Kirtland Air Force Base is submitting an Addendum to the Light Non-Aqueous Phase Liquid (LNAPL) Containment Interim Measures Work Plan Part 1 - Characterization, Bulk Fuels Facility Spill, Solid Waste Management Units ST-106 and SS-111. The original LNAPL Containment Work Plan was submitted to you in July 2011.

LNAPL Containment Workplan Addendum for the Bulk Fuels Facility Spill, SWMUs SS-111 and ST-106

**Subject: LNAPL Containment Well Location and Installation  
LNAPL Containment Interim Measures Work Plan Part I - Characterization, Bulk  
Fuels Facility Spill, Solid Waste Management Units ST-106 and SS-111  
Addendum November 2011  
Albuquerque, New Mexico**

**FIGURE 3**

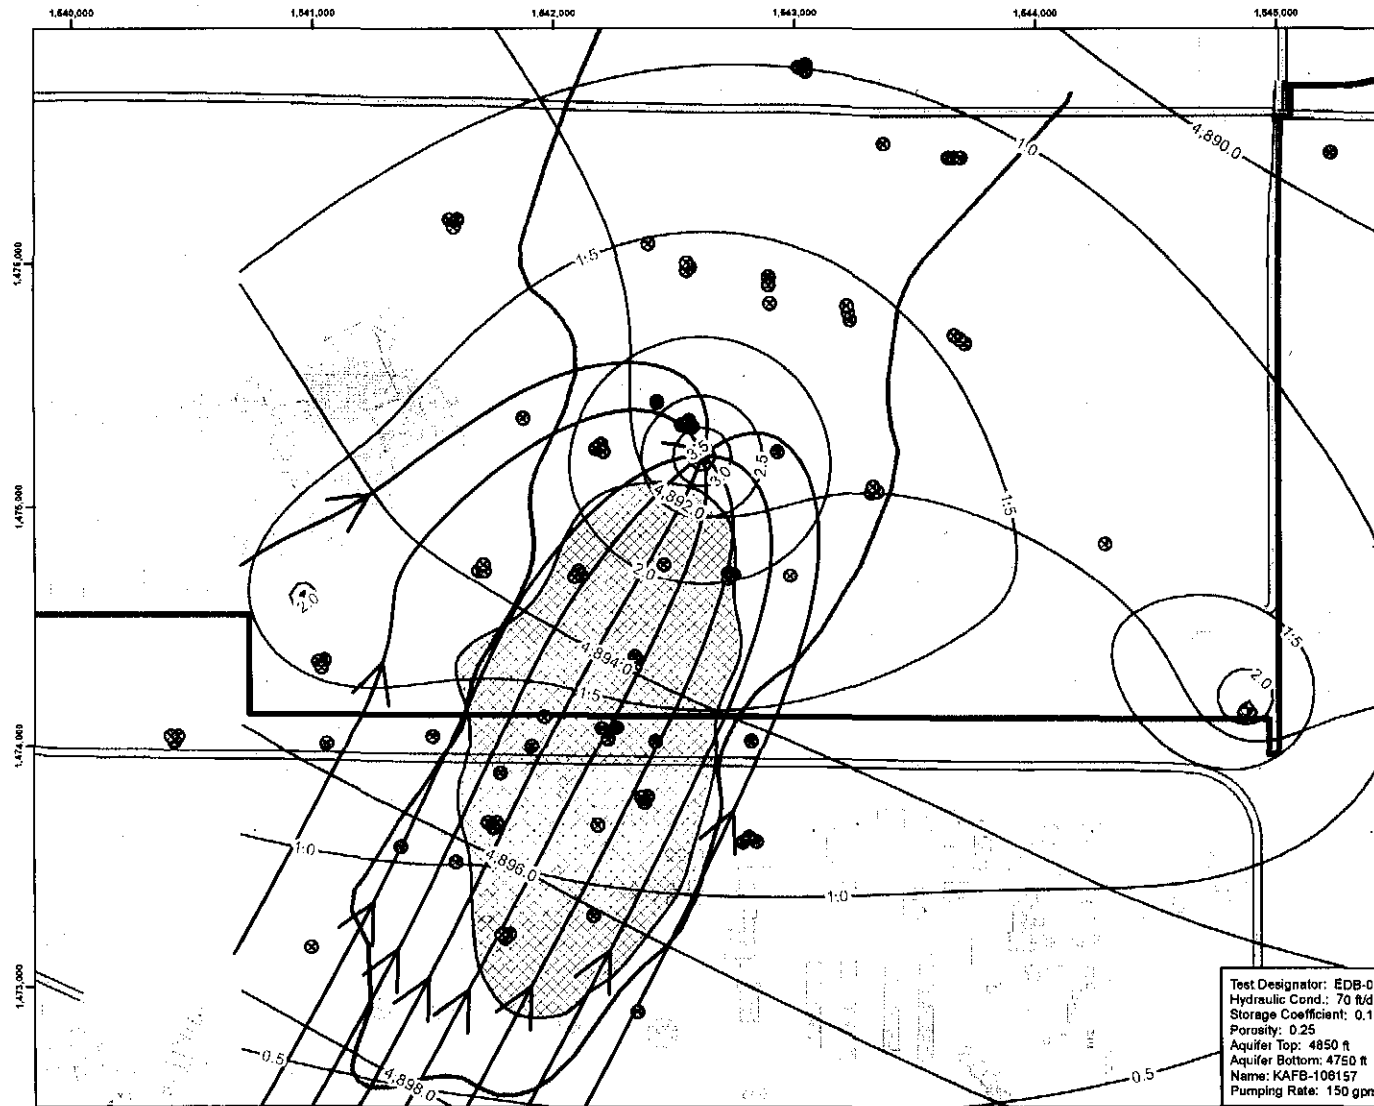
Shaw conducted a technical evaluation of the proposed containment well location and quantity as a result of discussing with the NMED Tiger Team on 3 November 2011. As a result of that evaluation, Shaw determined that a single containment well would be sufficient for containing the LNAPL, meeting the primary objective of the containment system and work plan. The proposed change is to move KAFB-106157 approximately 180 feet southeast of the original location (Figures 1 and 2). Figure 3 shows the predicted capture zone of this containment well, using the most recent hydrogeological data and recently acquired production well data for both Kirtland Air Force Base (AFB) wells and the Albuquerque Bernalillo County Water Utility Authority (ABCWUA) wells.

Figure 4. Extraction Well Construction

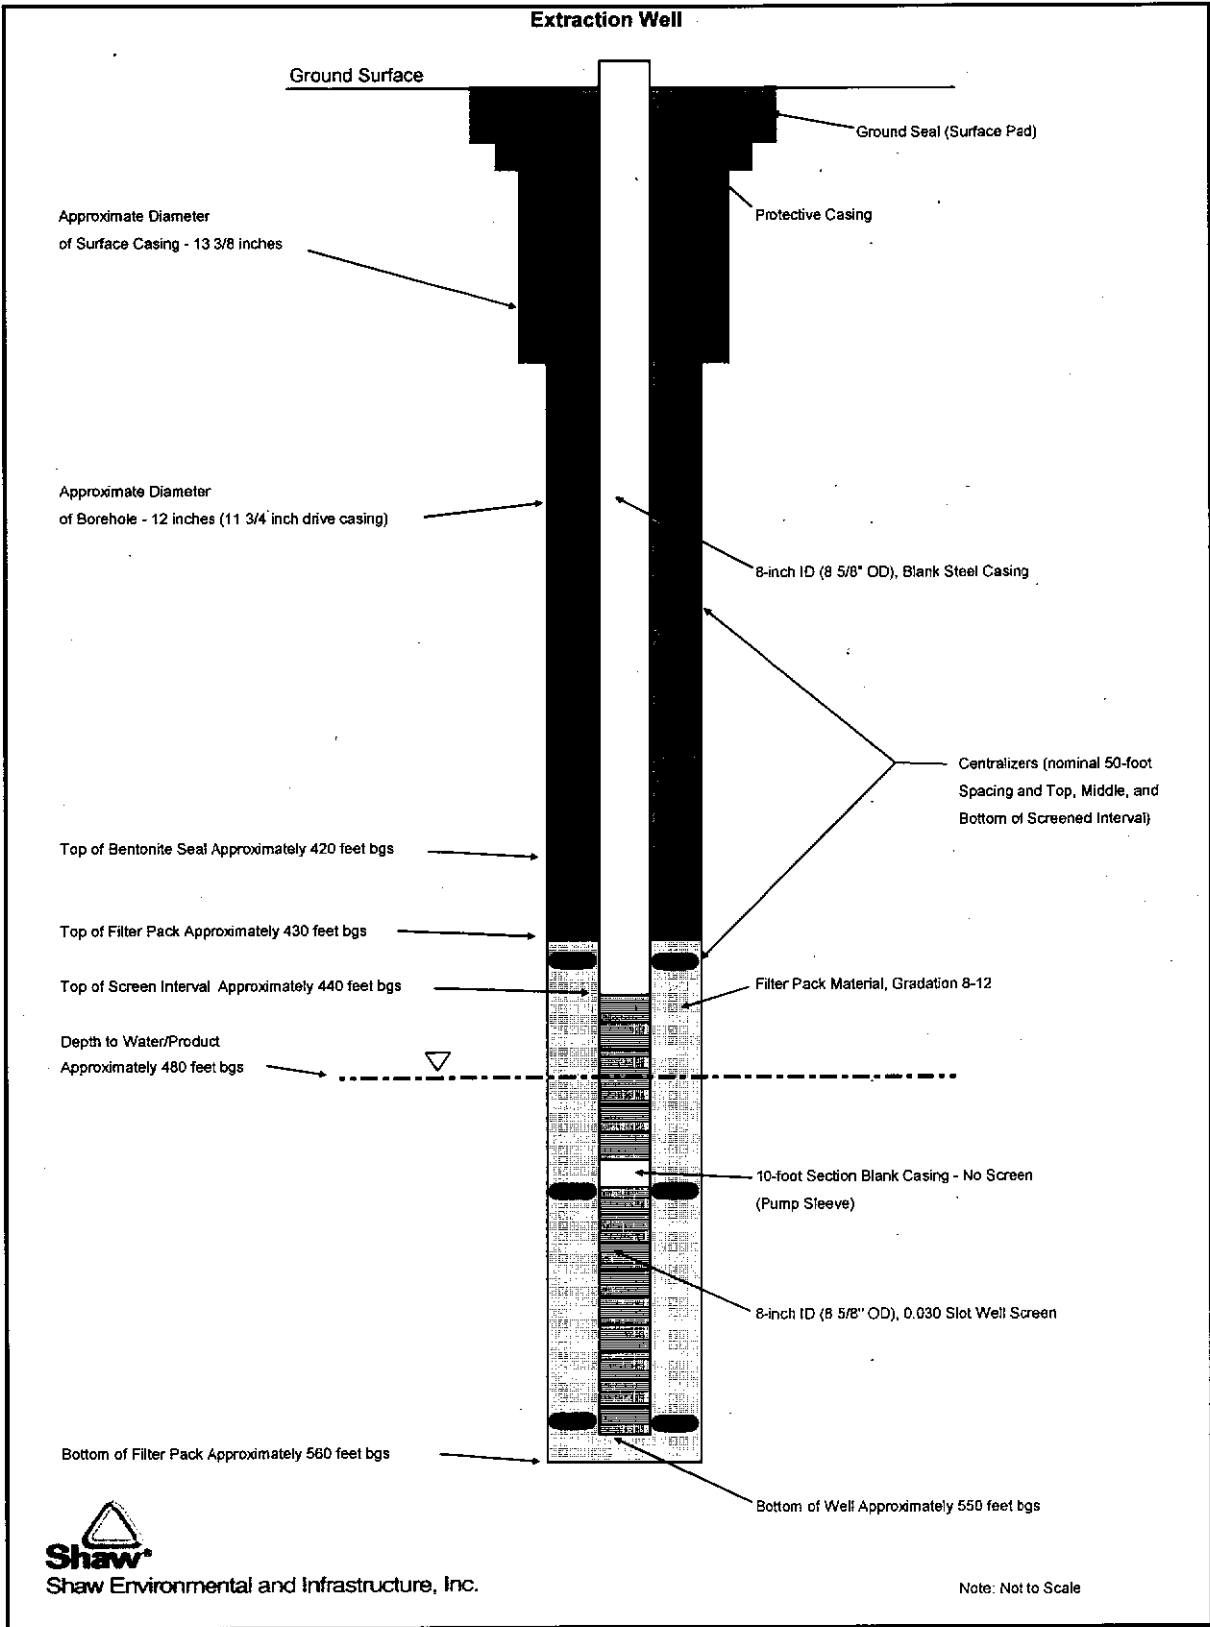
In order to accommodate the documented rise in water levels in the project area, the screening interval of the LNAPL containment well has been revised from what was proposed in the work plan. Figure 4 is a schematic diagram of the proposed well construction. Below is the proposed procedure and well design for the LNAPL containment well KAFB-106157:

- KAFB-106157 will be constructed with 90 feet of 8-inch diameter welded joint 0.030 slot stainless steel continuous wrap screen with double strong wires and rods, a 10-foot blank stainless steel pump sleeve section placed approximately 30 feet below the current water table, and a Schedule 40 carbon steel casing riser (Figure 2). The well will be constructed with 60 feet of screen/pump sleeve below the water table and 40 feet of screen above the water table to accommodate future water table rises. The steel well casing will extend approximately 2.5 feet above grade as a temporary completion during well development. The final depth of the pump sleeve will be decided in the field based on lithology encountered during drilling.

- An engineered 10-20 sand pack filter pack will be installed in the annular space between the well casing/screen and the borehole from the bottom of the borehole to approximately 10 foot above the top of the screened interval. The filter pack will be slurried with clean potable water and tremied into place to prevent bridging and to ensure continuous placement, while the drive casing is slowly removed. A 10-foot hydrated bentonite seal will be emplaced above the sand filter pack and incrementally hydrated with potable water in 1-foot lifts.
